# SERVICE BULLETIN

Classification: BT95-003	Reference: NTB95-041	Date: June 7, 1995
-----------------------------	-------------------------	-----------------------

## 1995 MAXIMA SUPPLEMENT RESTRAINT SYSTEM (SRS) FLASHING LIGHT

**APPLIED VEHICLE:** 1995 Maxima (A32)

# DIAGNOSTIC FAULT TREE

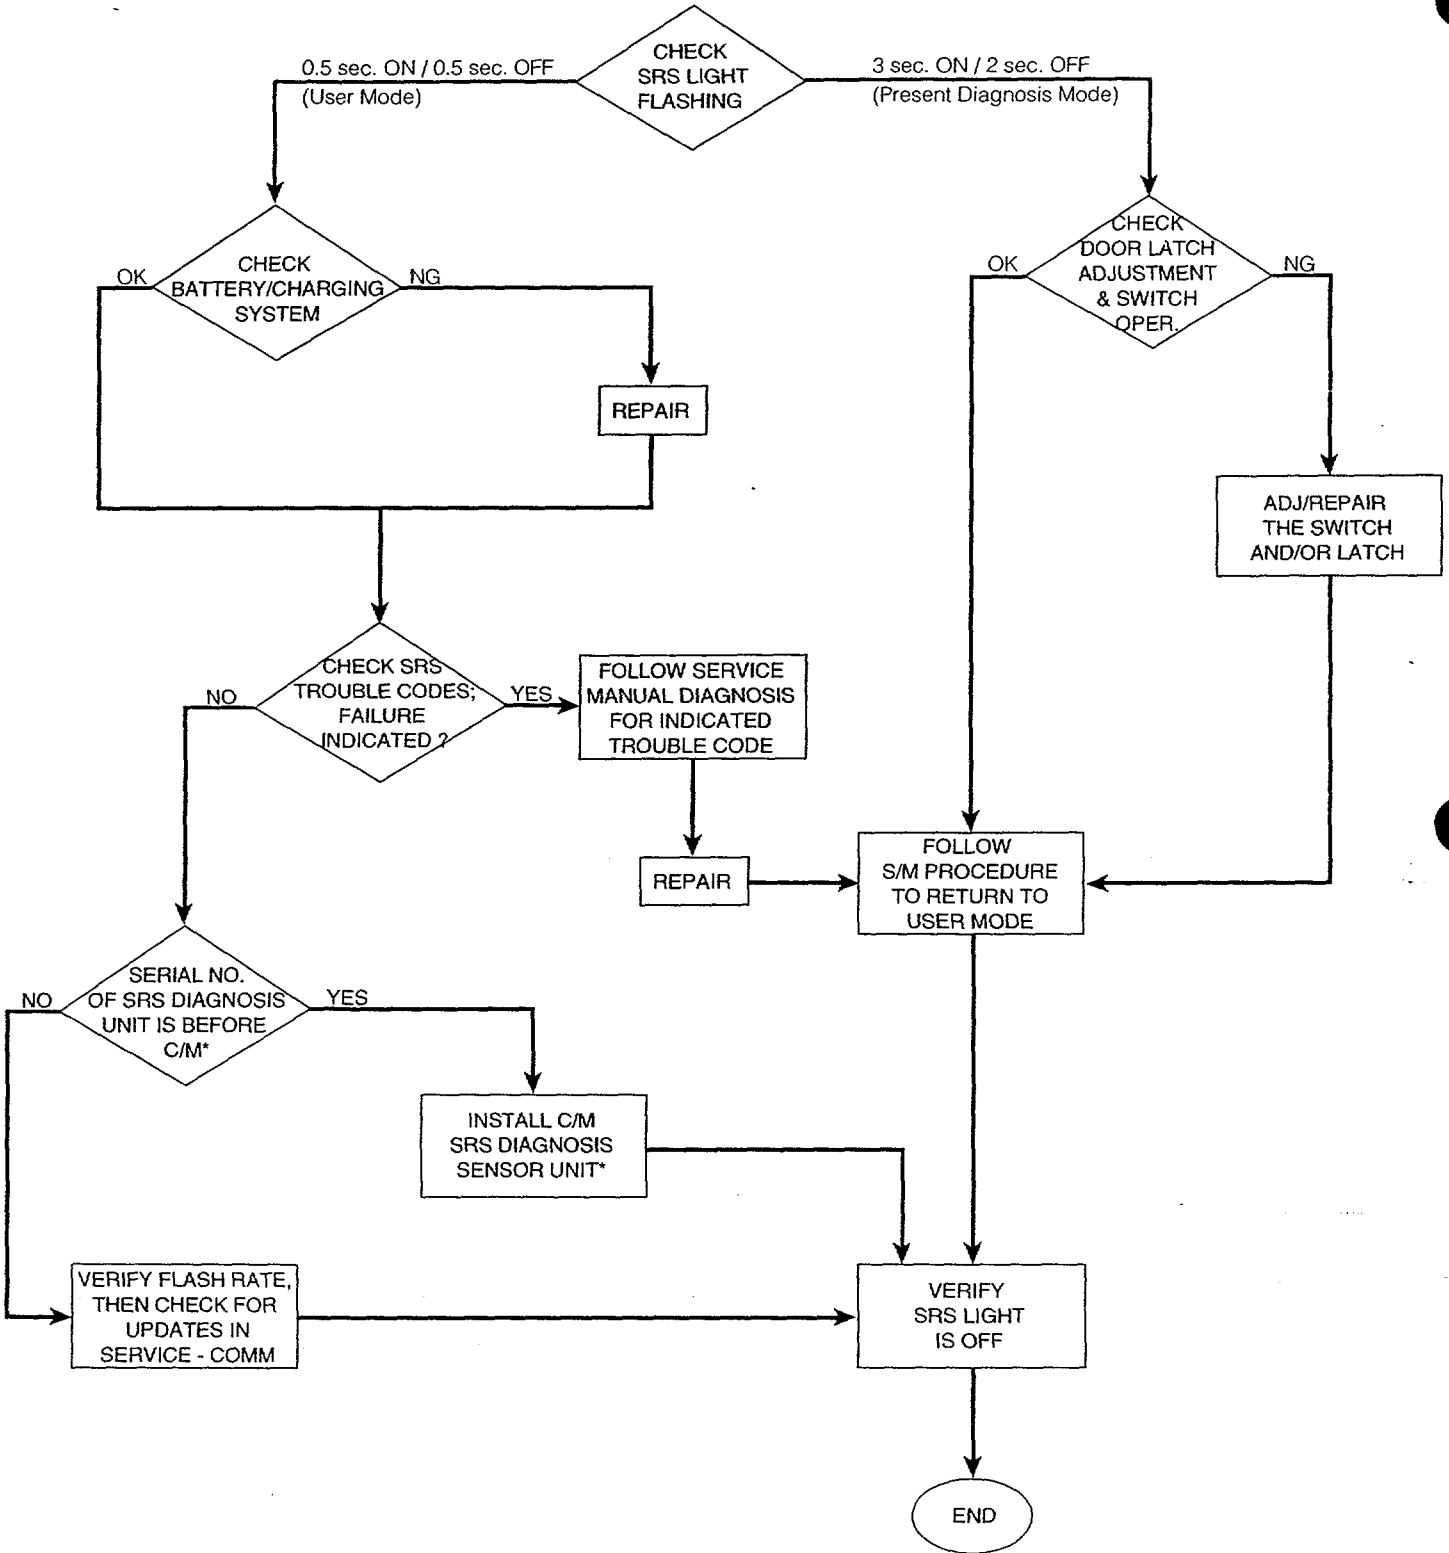
When diagnosing a blinking SRS warning light (with a blinking frequency of 0.5 seconds on/0.5 seconds off *or* 3 seconds on/2 seconds off), the attached diagnostic fault tree should be followed especially when CONSULT indicates no failure detected.

If conditions indicate replacement of the SRS diagnosis sensor unit, a countermeasure (C/M) unit *must* be installed in the vehicle.

The diagnosis sensor unit is designed to monitor the vehicle battery voltage. The original unit (on vehicles built before August 1994) will send a signal for the SRS warning light to flash (user mode) if the vehicle battery voltage drops below 7.6 volts. The C/M unit still monitors the vehicle battery voltage, but will not activate the SRS warning light unless the battery is extremely low.

\*C/M Serial No. of production SRS DIAGNOSIS SENSOR UNIT begins with SE41U946170022 (~August 1994)  
 C/M Serial No. of service SRS DIAGNOSIS SENSOR UNIT begins with SE41U948240424

If vehicle already has C/M Diagnosis Sensor Unit, check for updates in SERVICE-COMM
